### Proposed Revisions to a Standard Plans Index

Index Number: 700-020

Index Title: MULTI-COLUMN GROUND SIGN

**Summary of the changes:**

FRONT ELEVATION  
BACK ELEVATION  
MULTI-COLUMN SIGN ASSEMBLY

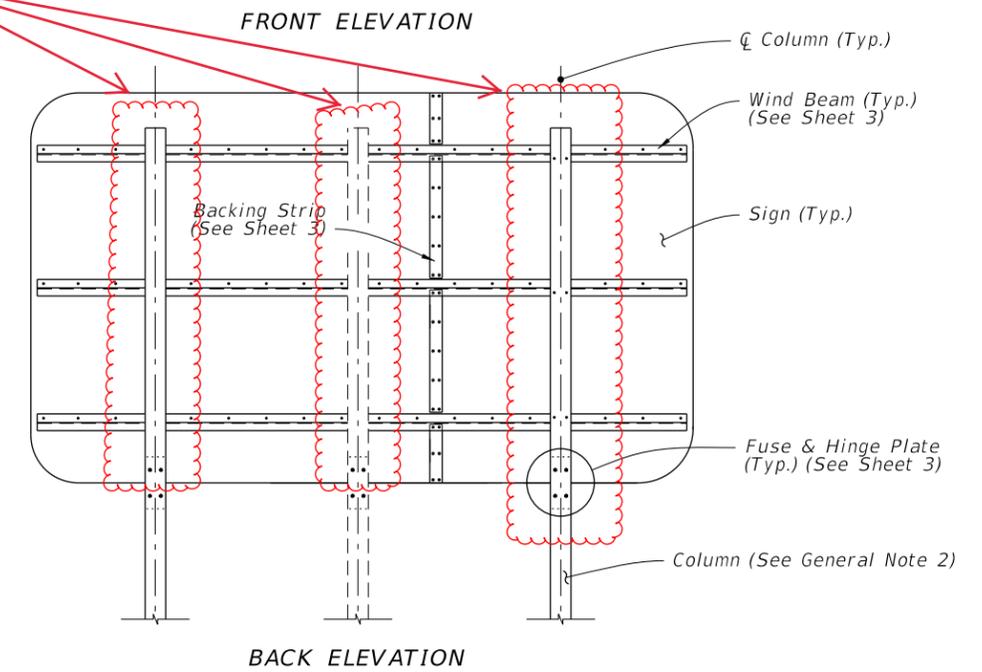
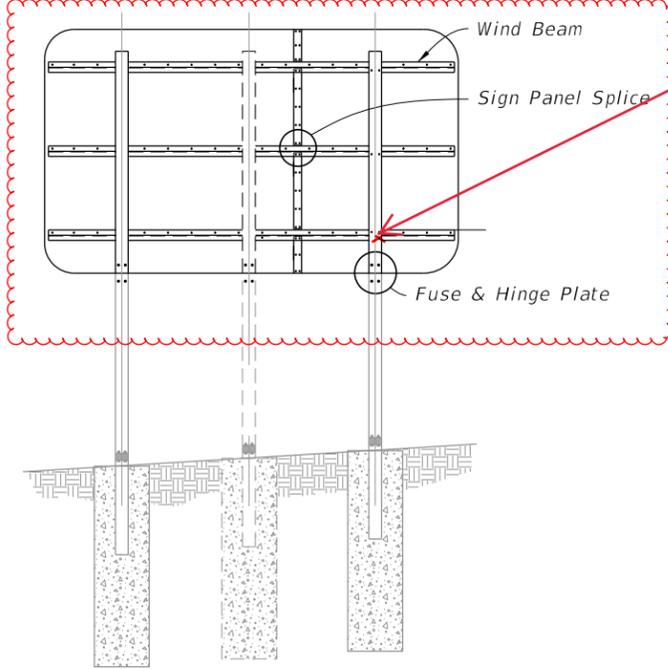
Sheet 1: Revised bolts in the Hanger Beams to show correctly.

The bolts were not showing correctly in the elevation details.

Show the same bolting on the other wind hanger beams

**SIGN PANEL SPLICE**

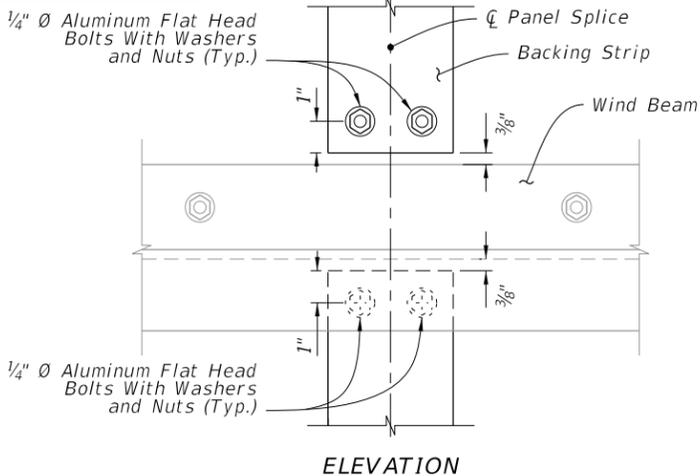
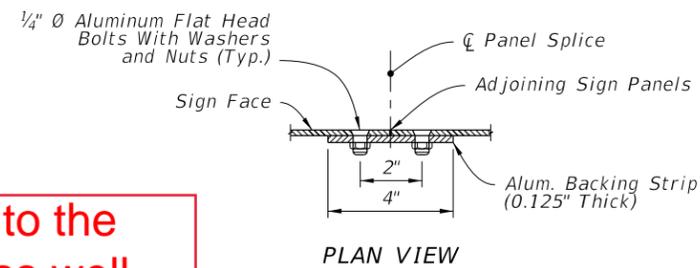
**Only 2 bolts per intersection**

**Add the bolts to the other beams as well**
